Town of Evans, Erie County, State of New York
SOUTH CREEK POOL HOUSE PROJECT
ADDENDUM 2 - 9.11.2026

ADDENDUM #2

A – BID RFI RESPONSES

Bathrooms Counter 6'x2'-0" C-1

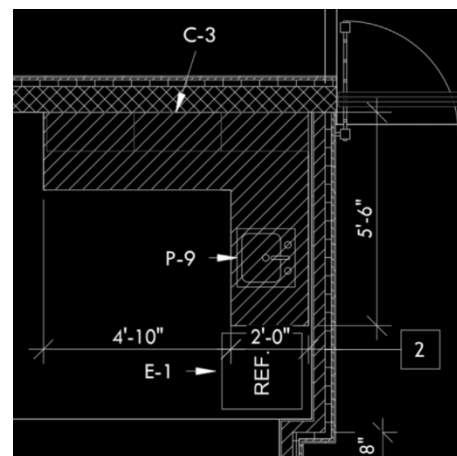
14. RFI 005 Counter Clarifications: Please clarify the counter dimensions, profile and materials for the bathroom counter and office counters.

Response:

Office Counter C-4 7'-10" x 2'-0"

Office counter C-2 4'-8"X2'-0"

Office counter L-shape C-3 (see attached image)

Countertops material - solid surface

(All heights per ADA standards)
